REMARKS

I. THE PRESENTLY CLAIMED INVENTION

Figure 1

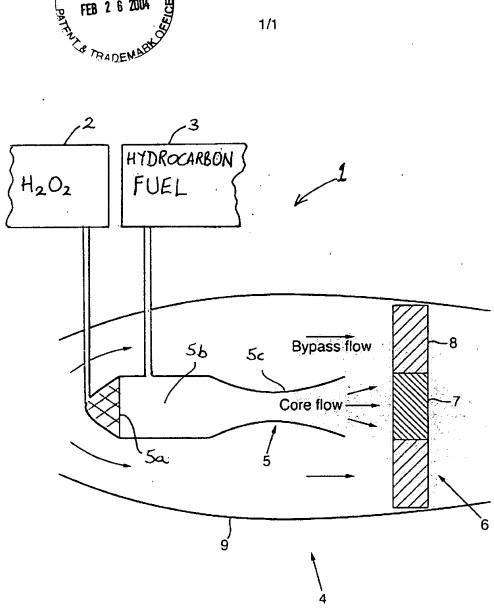
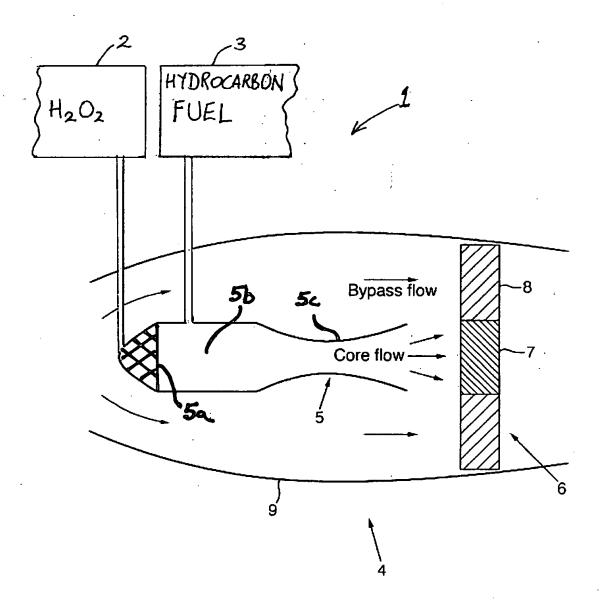
The Examiner objected to the drawings under 37 CFR 1.83(a). The Examiner explained that the drawings must show the decomposition region and the combustion region as described in the specification and claims.

The Examiner's objection has been overcome by amending Figure 1 to include numeric designations for the decomposition region with catalyst (5a), combustion region (5b), and nozzle (5c). The specification has been amended accordingly to include the same numeric designations – 5a, 5b, and 5c in the description of the Figure 1 features. These features find support in the specification at, for example, page 1, lines 15-20 and page 2, lines 15-22.
